**Traffic and Transport Expert Evidence  
Glen Eira Planning Scheme Amendment  
C155**

22 November 2019

Glen Eira Planning Scheme Amendment C155

**Figure 6.2 – Bus Capable Connector Street – Exhibited CDP**

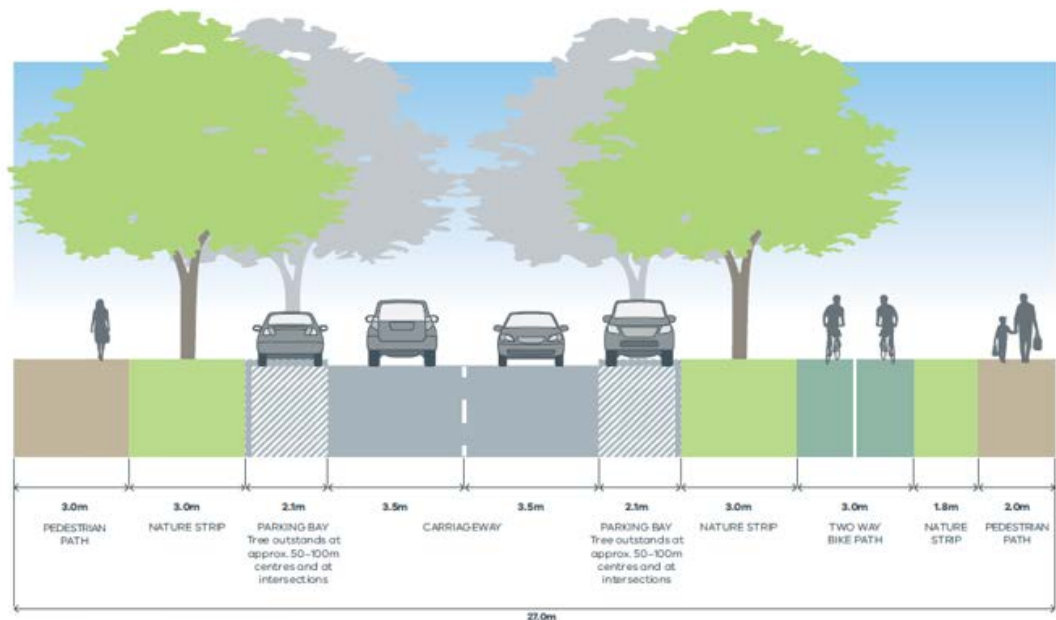
- 6.2.2 The plan proposes a 27.0m wide reservation, providing a 7.0m wide carriageway with 2.3 m parking lanes on each side, together with a 3.0m pedestrian path on one side , a 3.0m wide bike path and a separate 2.0m pedestrian path on the other.

**Figure 6.3 – Proposed Revised Connector Road Cross-section**

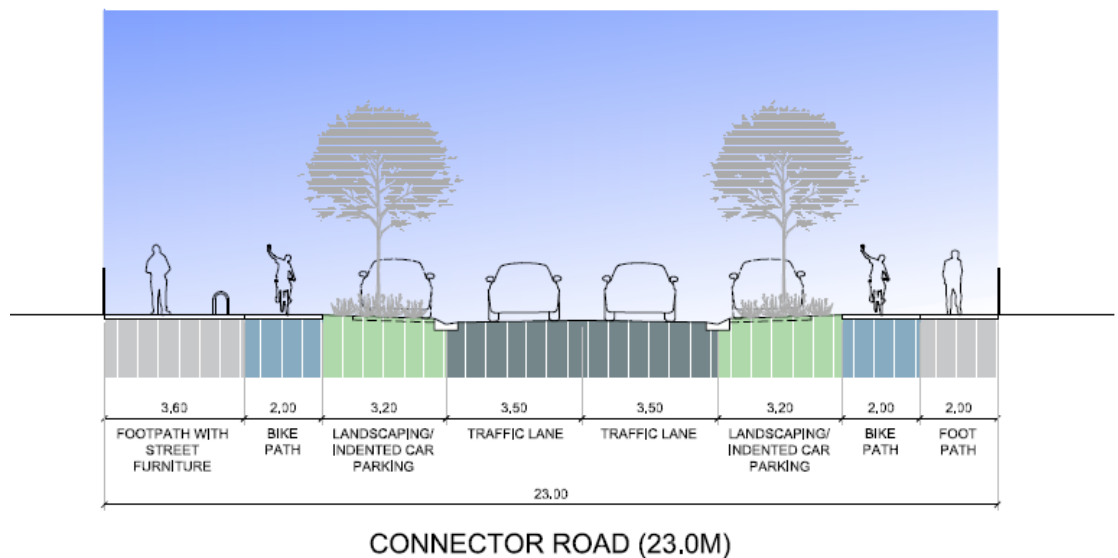
- 6.2.4 The revised cross-section retains the 7.0m carriageway required for buses, providing landscaping within a widened parking landscaping verge on each side. Footpaths of 3.6m are provided on one side, allowing street furniture and 2.0m on the other, together with separate 2.0m wide (one way) bike paths on each side.

- 6.2.5 In movement and functional terms, the revised cross-section is appropriate, to allow for the connector streets to operate as bus routes and, as such I am comfortable with the reduced reservation width as proposed.

- 6.2.6 In my opinion, one way off road bike paths on each side of the carriageway, requiring a cyclist to cross the road to make a return journey are not practical, and I recommend that, if adopted, that the revised cross-section provided for a single 3.0 wide two way path on one side of the road only.

6.2.7 This can comfortably be accommodated in the proposed 23m reservation.

SCALE 1:500 (A3) 0 2.5 5 7.5 10 SHEET No. 1 of 6 DWG No. G24360-B-04

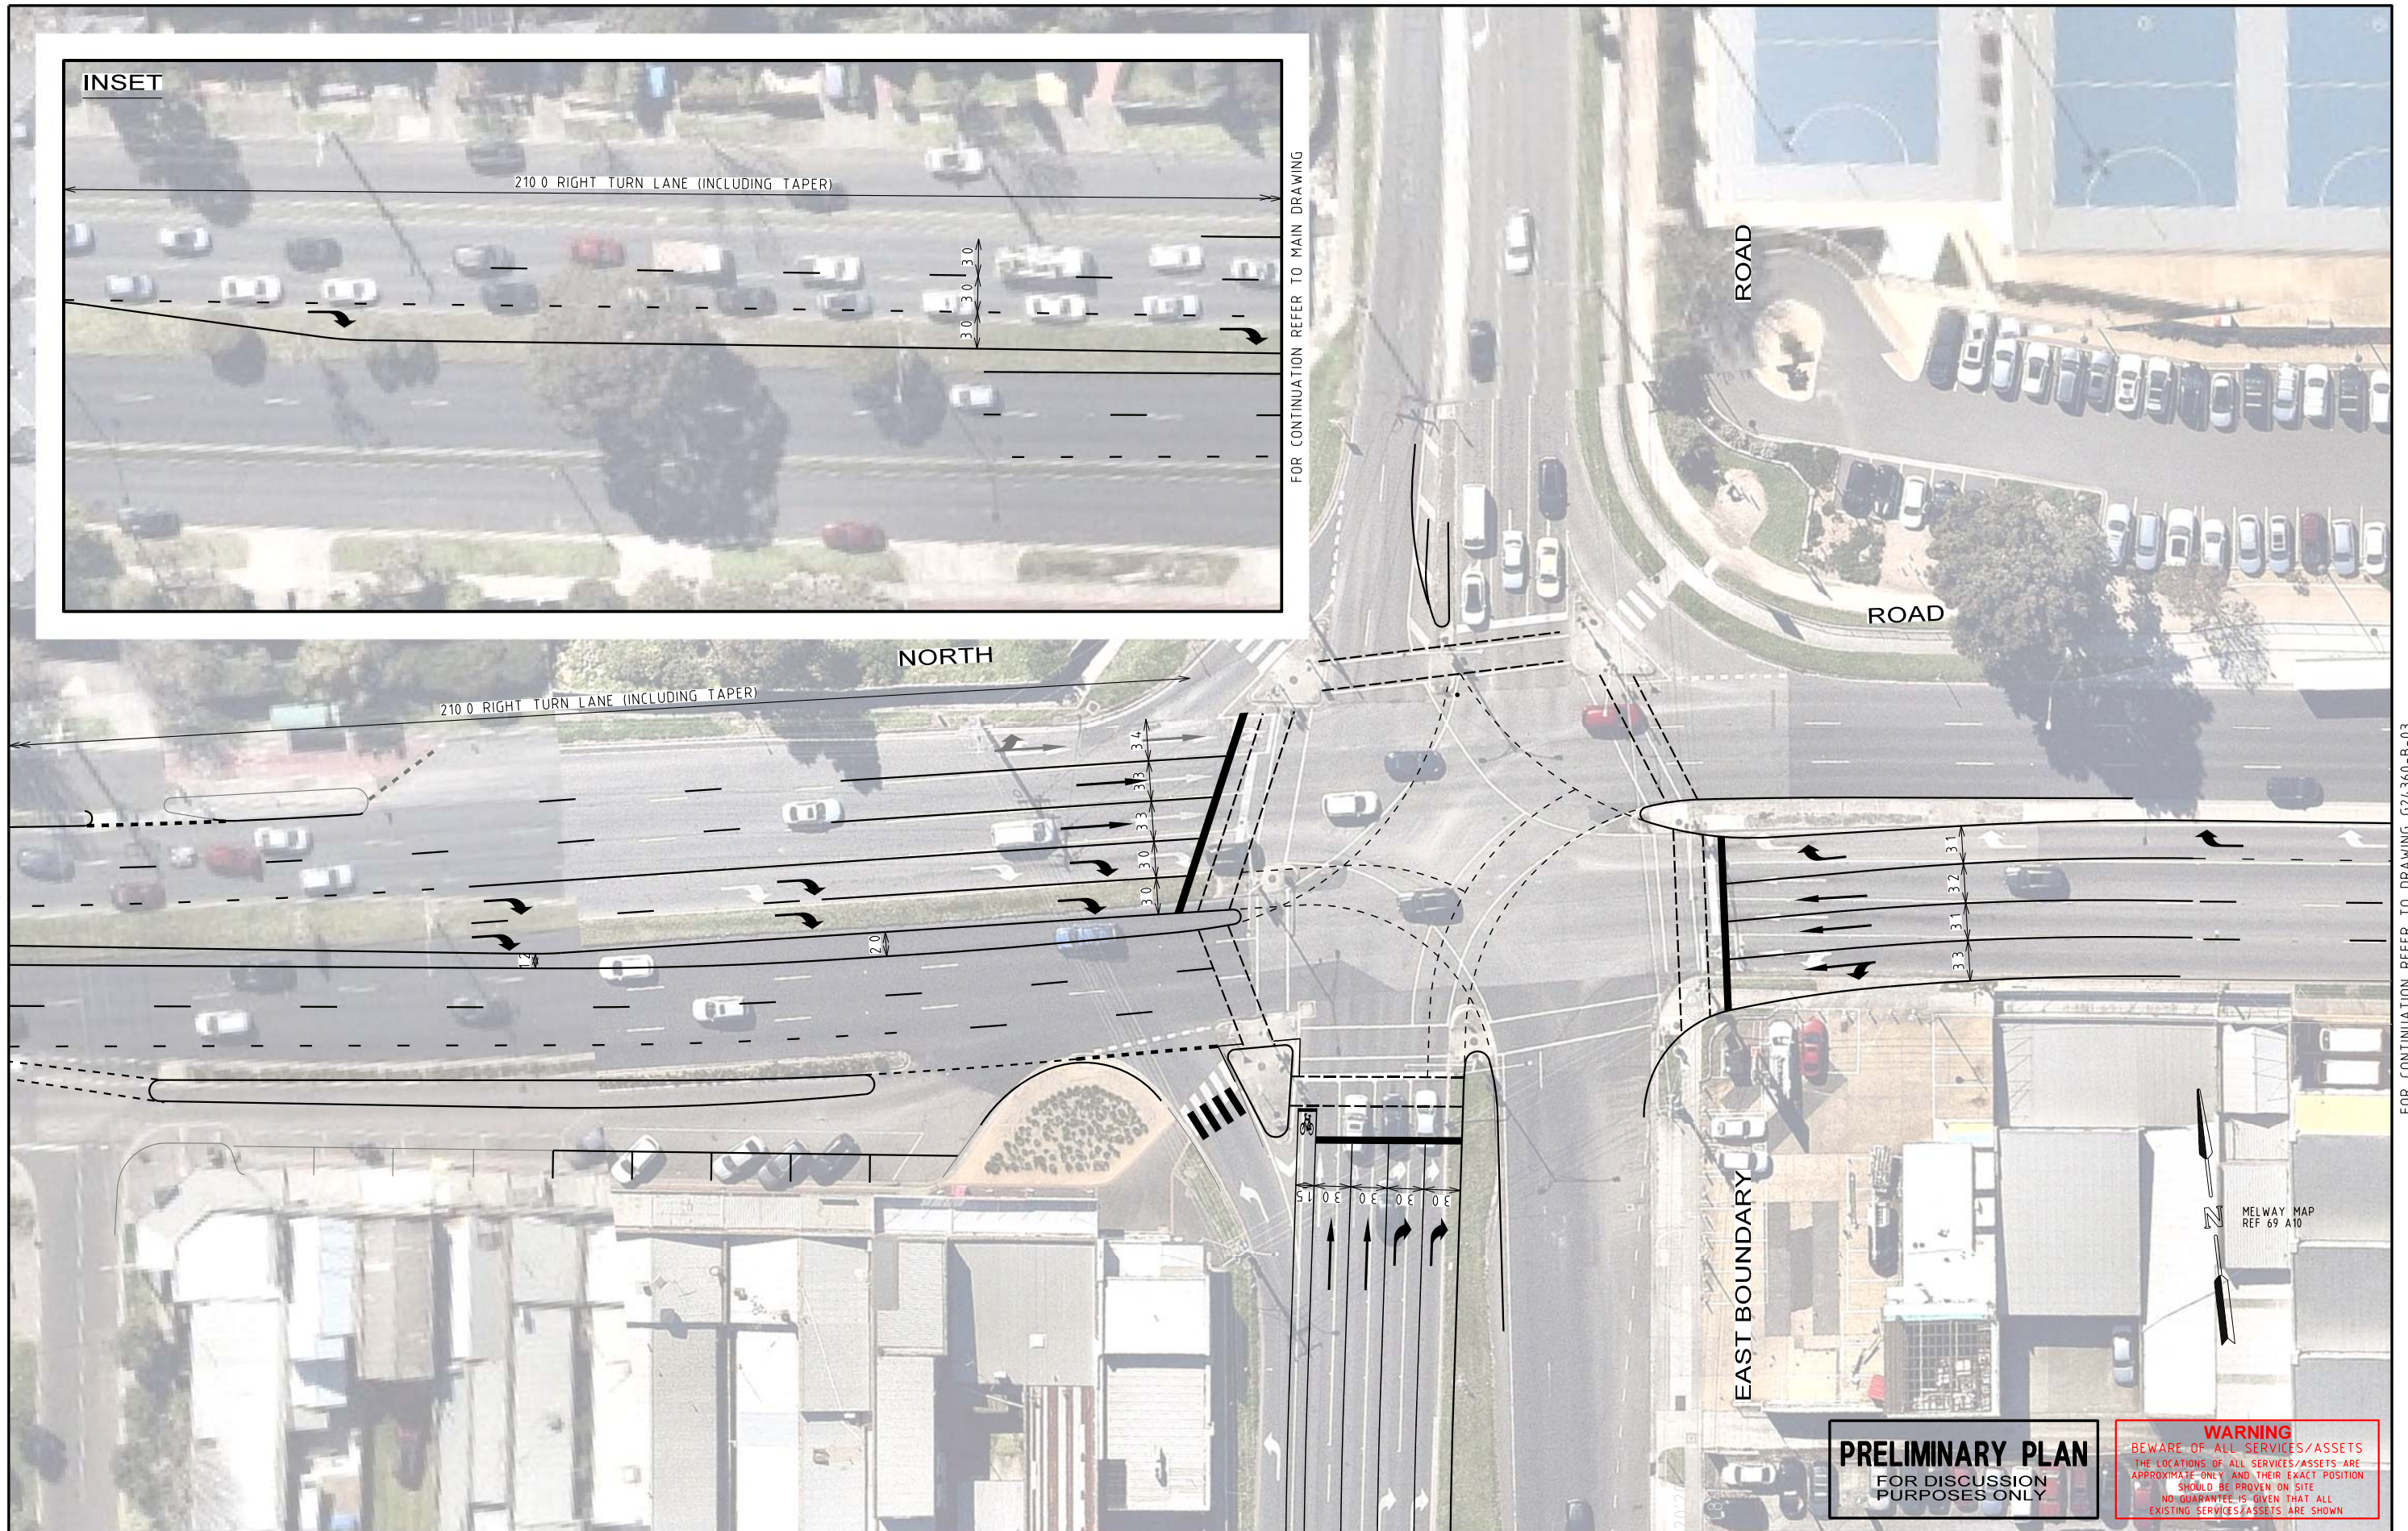
- 5.2.9 Based on my review of the analysis undertaken by GTA and Traffix Group, I am satisfied the intersection works as now proposed in Traffix Plans G244360-B03, G244360-B04 and G244360-B05 represents an appropriate extent of works for inclusion in the DCP, providing sufficient capacity to mitigate the impacts of development of the East Village Precinct.

SCALE 1:500 (A3) 0 2.5 5 7.5 10 SHEET No. 5 of 6 DWG No. G24360-B-06

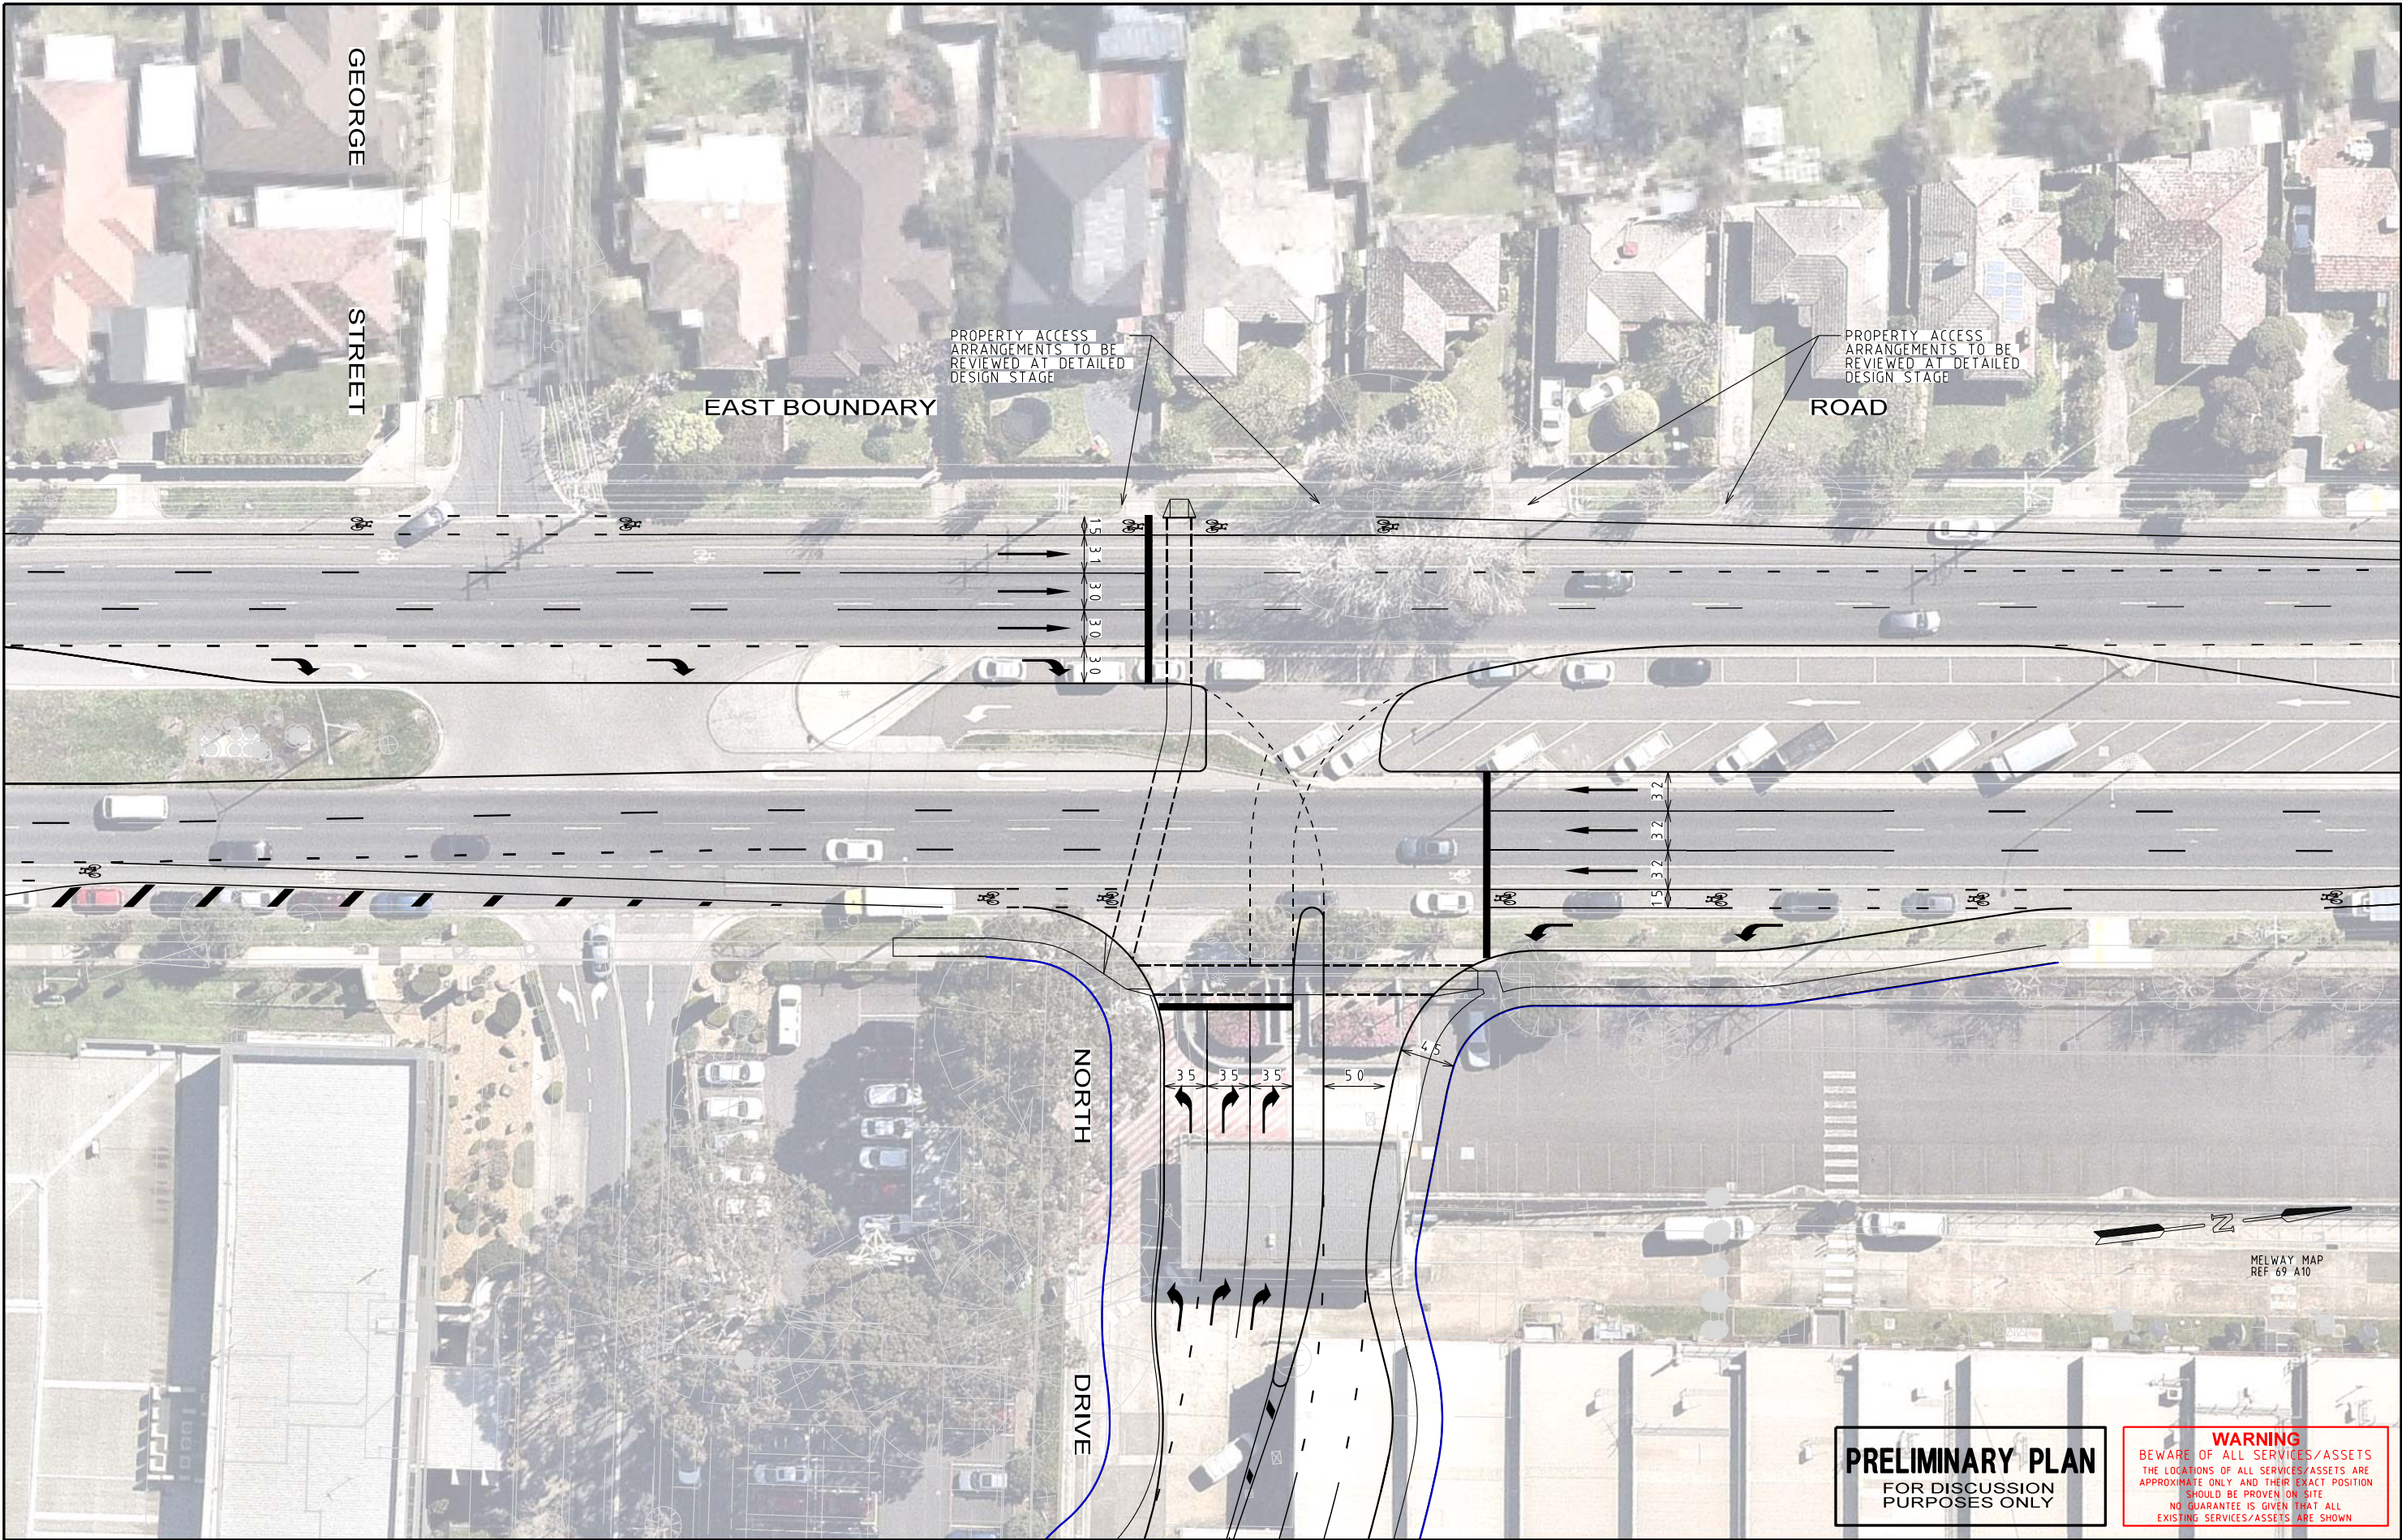
- 5.5.3 The revised proposal prepared by Traffix Group (Plan G24360-B-06) proposes to relocate the intersection to the north, to a location approximately 60 metres north of the George Street intersection, with George Street removed from the signals and reverted to a left in / left out intersection to East Boundary Road.

- 5.5.4 In addition, in order to reduce pedestrian crossing distances through the intersection it is proposed to delete the left turn slip lanes, providing for left turn lanes through the signals on the north and eastern approach.

- 5.5.5 The proposed additional third through lane in East Boundary Road through the North Drive intersection is retained in the Traffix proposal.
- 5.5.6 I have reviewed the revised proposal and accompanying analysis undertaken by Traffix Group as documented in the memo of the 18<sup>th</sup> November 2019 and I support the modifications as proposed.
